Addendum No. 1

IFB-25-00070

Sun City Fire Station No. 47

REASON(S) FOR ADDENDUM:

L-1.3

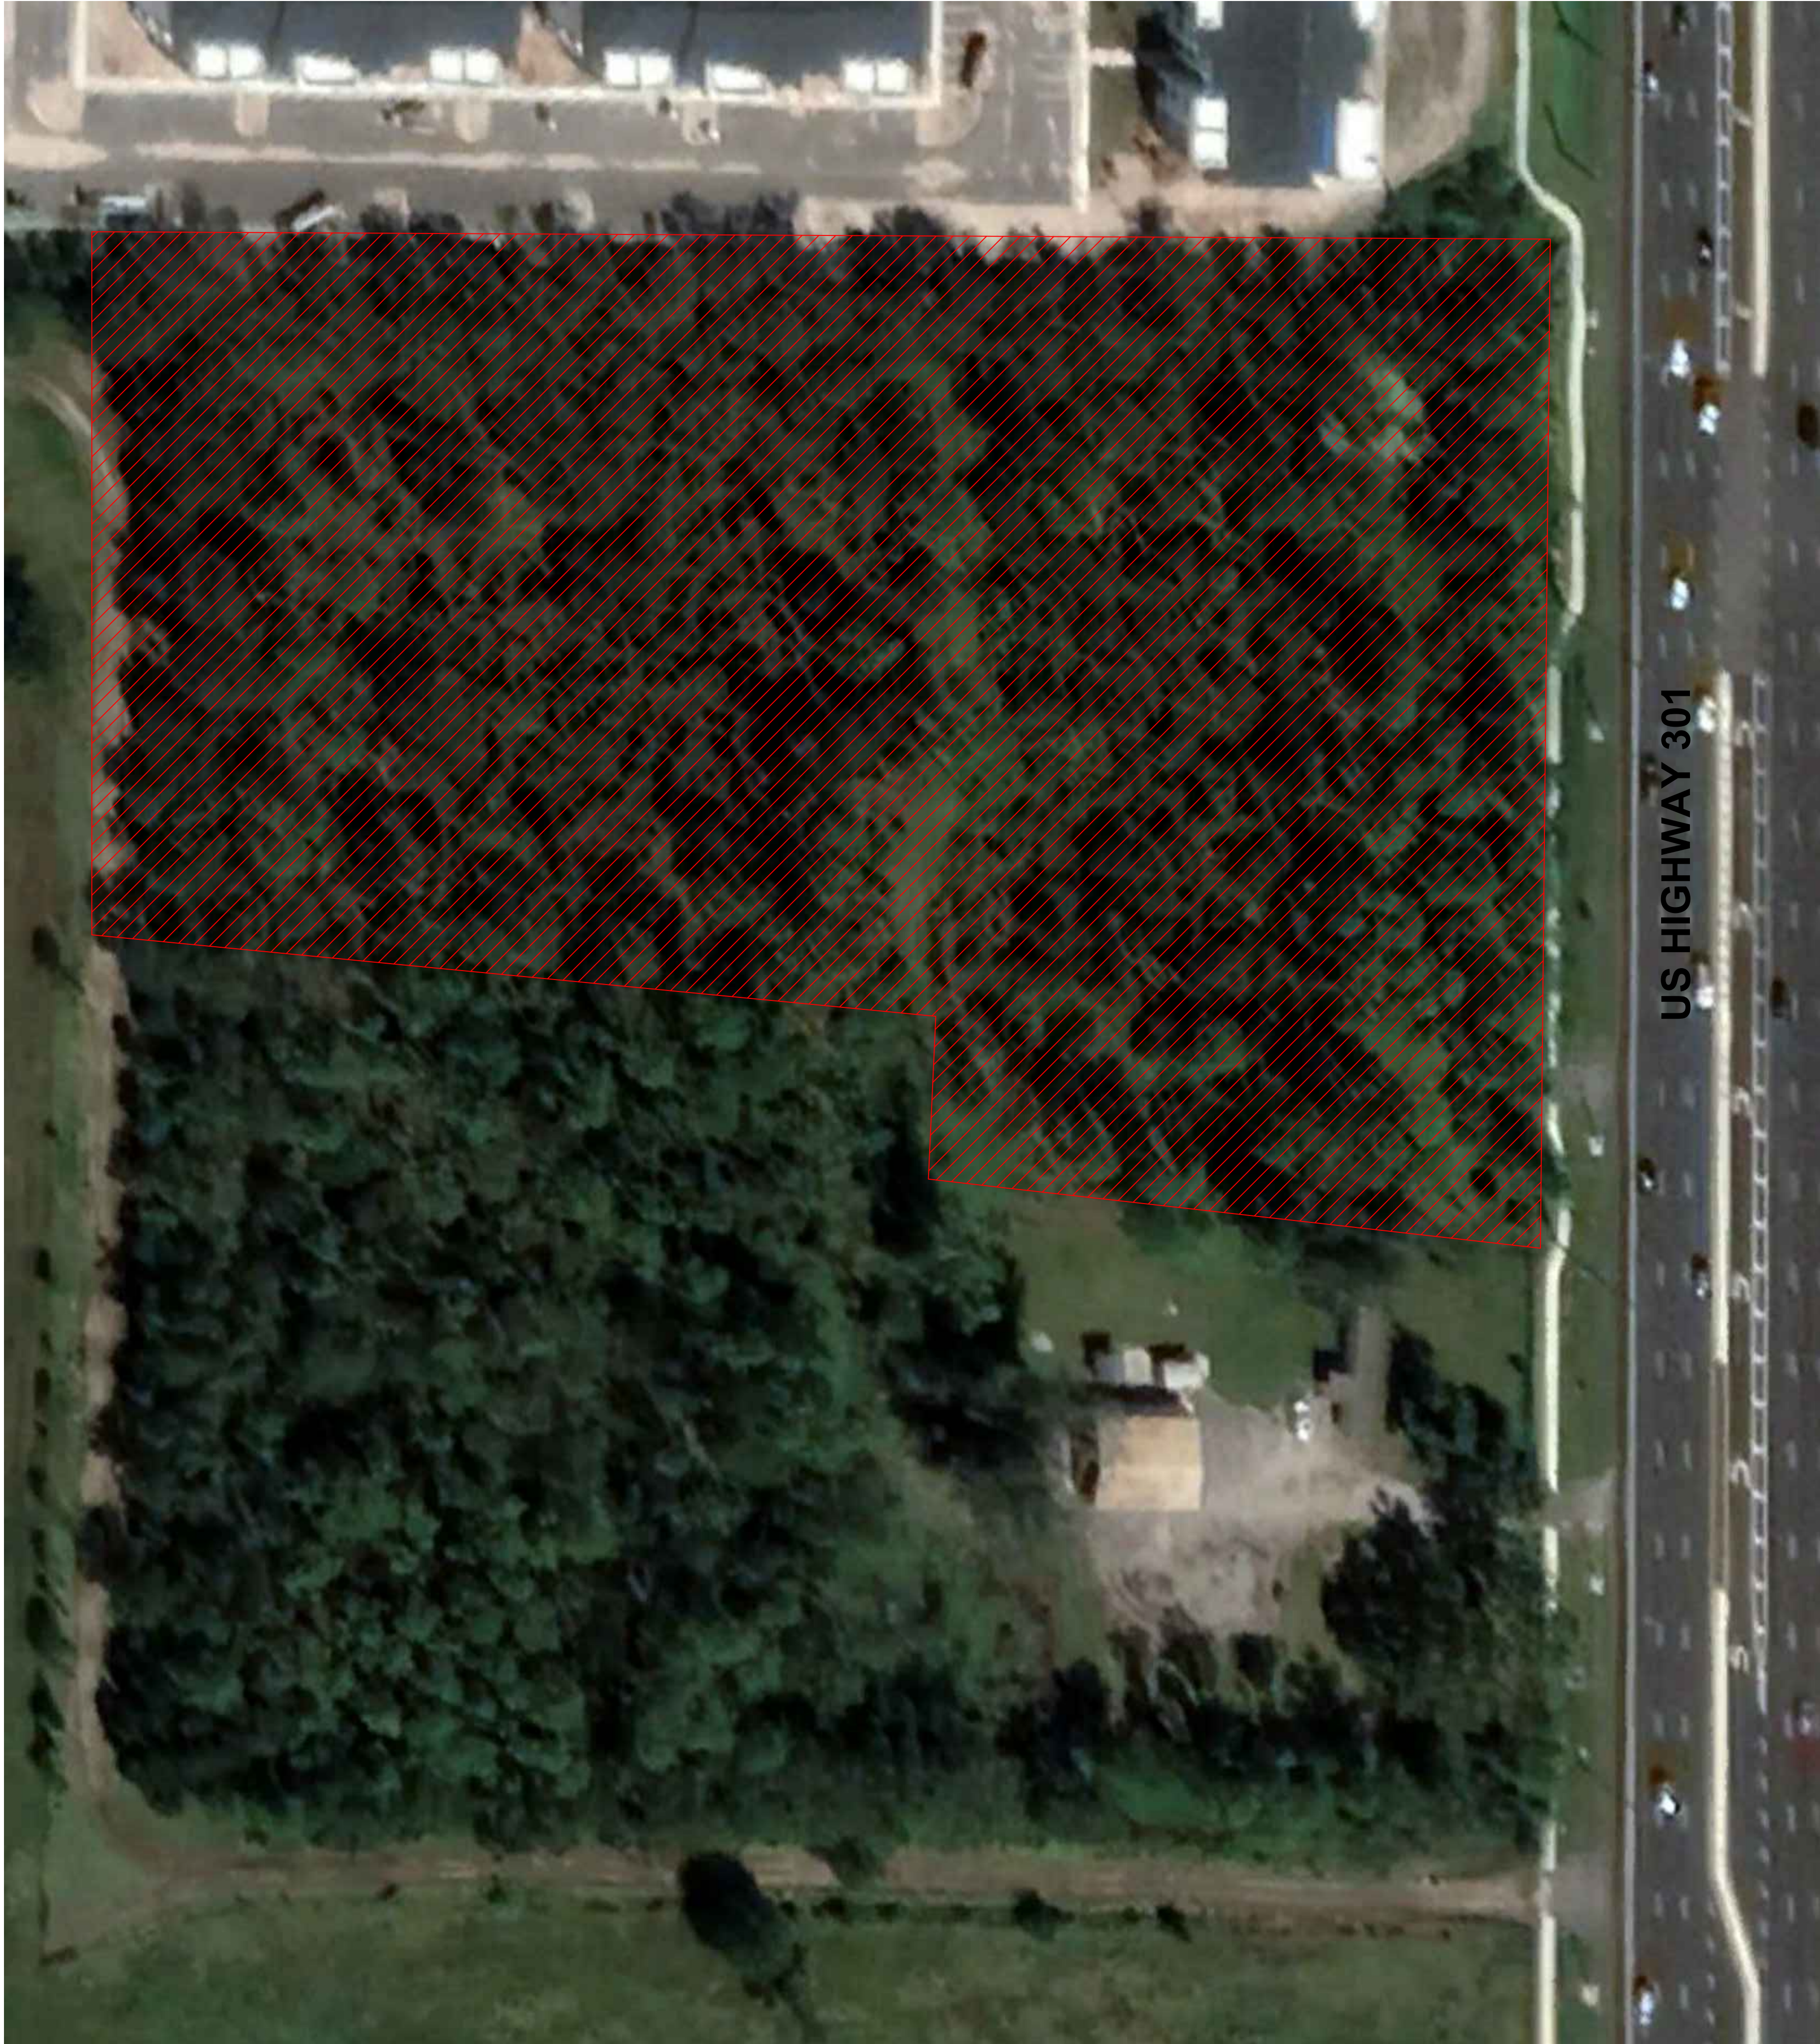
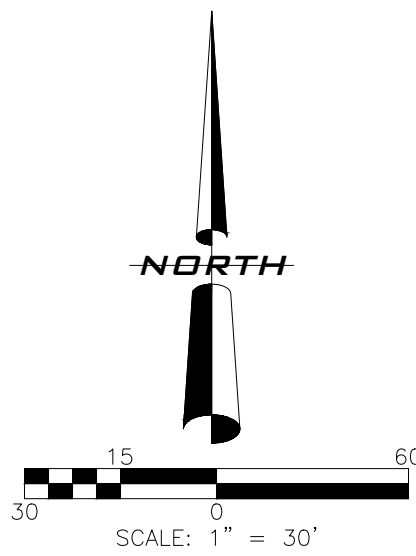
Question No. 75: Sheet L1.3: Invasive Species Report/Monitoring: Per note on sheet who is responsible for the Invasive Species Reporting / Monitoring for the project? If the GC, can this be limited to only the 1-year warranty period in lieu of the extended timeline as stated within the note?

Question No. 85: Confirm the contractor is NOT responsible for the post removal maintenance program related to the invasive trees/plants per the notes on Sheet L-1.3 requiring inspections and reporting every 6 months for a period of 5 years.

Response: The General Contractor is responsible to provide the Post Removal Maintenance Program and the Invasive Species Reporting until the end of the 1 – Year Warranty period, the remainder of the Post Removal Maintenance Program and the Invasive Species Reporting shall be done by the Owner, see revised Sheet L-3.

Response: The General Contractor is responsible to provide the Post Removal Maintenance Program and the Invasive Species Reporting until the end of the 1 – Year Warranty period, the remainder of the Post Removal Maintenance Program and the Invasive Species Reporting shall be done by the Owner, see revised Sheet L-3.
